Work Order ID 69687

Item Name: Crosstube Turning Detail

DART AEROSPACE LTD	Work Order:	69687
Description: Crosstube Assembly (205/212/412 High Fwd)	Part Number:	D212-664-141
Inspection Dwg: D212-664-141 Rev: D		Page 1 of 1

DRAWING NO. D212-664-141	TITLE XTUBE ASSY (205/212/412 HI FWD)	REV. D	DART AEROSPACE LTD ENGINEERING ORDER		D.E.O. NO. D212-664-141-D-1	SHEET NO. SHEET 1 OF 2	SCALE NTS
DRAWN	CHECKED <i>UP</i>	MFG. APPR. <i>BE</i>	APPROVED <i>MP</i>	DE APPR. <i>MP</i>			
DATE 11.04.07	DATE 11.07.11	DATE 11.04.12	DATE 11/04/12	DATE 11.04.12

D212-664-141/-141B
ASSEMBLY DETAIL

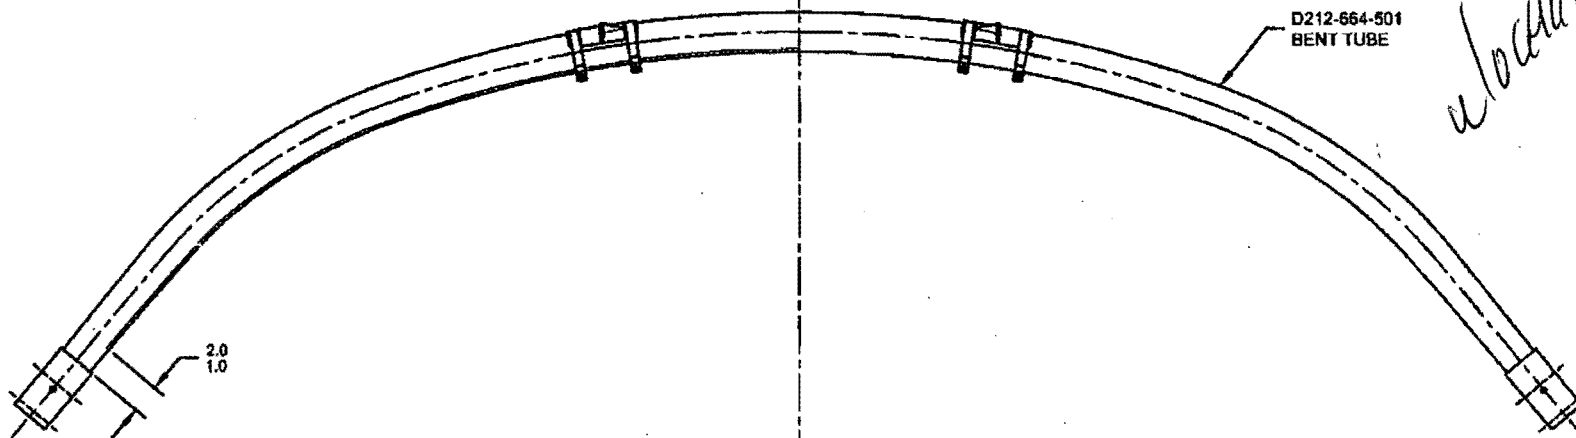
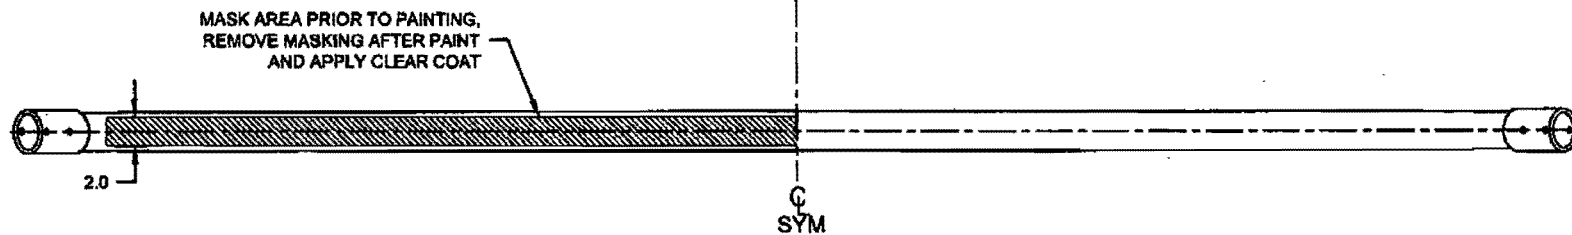
PURPOSE:

ADD AN INSPECTION WINDOW TO UNDERSIDE OF CROSSTUBE.

NOTES 2 OF SHEET 1 IS AMENDED AS FOLLOWS:

- 2) FINISH: CHEMICAL CONVERSION COAT PER DART QSI 005 4.1
PRIME INSIDE AND OUTSIDE PER DART QSI 005 4.2
MASK UNDERSIDE OF CROSSTUBE AS SHOWN (HATCHED AREA) AND
PAINT OUTSIDE PER DART QSI 005 4.2
REMOVE MASKING AND APPLY CLEAR COAT
